Access Compliance Report

Public Rights-of-Way

(Curb Ramps)

Intersection ID: 46590	Main Street: QUAKING_GRASS_CT	Cross Street: RABBITS_FOOT_LN	Location: S
ADA ID: 217F6ED7B7E9	Ramp Type: Perp	Initial Pass/Fail: Fail	Overall Compliance: No
			Severity Score: 13.75

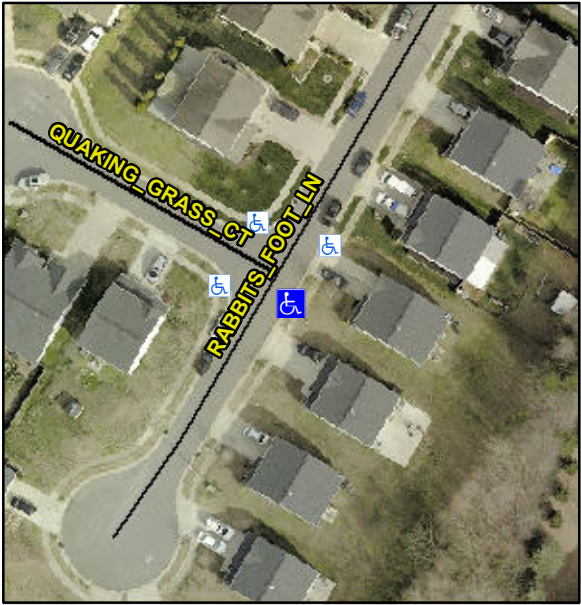
Codes/Mitigation Info/Possible Solution			Field Measurements/Component Compliance		
	Possible Solutions:		Compliance	Description	Data
	Remove & Replace Entire Ramp.		No	Ramp Length (in)	48.0
			Yes	Ramp Width (in)	49.0
			N/A	Flare Type LT	N/A
			N/A	Flare Slope LT (%)	N/A
			N/A	Flare Traversable LT?	N/A
			N/A	Landing Length (in)	N/A
			N/A	Landing Width (in)	N/A
			N/A	Landing Slope (%)	N/A
			N/A	Landing X Slope (%)	N/A
<p>Surveyor Notes:</p> <p>N/A</p> <p>PROW/ADA:</p> <p>Not Found, R304.2.2</p>			N/A	Flare Type RT	N/A
			N/A	Flare Slope RT (%)	N/A
			N/A	Flare Traversable RT?	N/A
			N/A	DWS Provided?	N/A
			N/A	DWS Contrast?	N/A
			N/A	DWS Length (in)	N/A
			N/A	DWS Full Width?	N/A
			N/A	DWS Offset (in)	N/A
			N/A	Shared Landing?	N/A
			N/A	Gutter Ponding?	N/A
			N/A	Gutter Lip Ht (in)	N/A
			N/A	Painted X Walk1?	No
				X Walk 1 Direction	To NW
			N/A	X Walk 1 Width (in)	N/A
				X Walk 1 Slope (%)	1.5
				X Walk 1 X Slope (%)	5.0

N/A	Ramp inside XWalk1?	N/A
			N/A	Road Slope (%)	N/A
			N/A	Road X Slope (%)	N/A
			N/A	Any Obstructions?	N/A
				Obstruction Type	
			N/A		
			N/A		
			N/A		
			N/A		
			N/A		
			N/A		
			N/A		
			N/A		
			N/A		
Total Cost:		\$ 1850.00			
			N/A		
			Yes	Surface Condition? (G/P)	Good
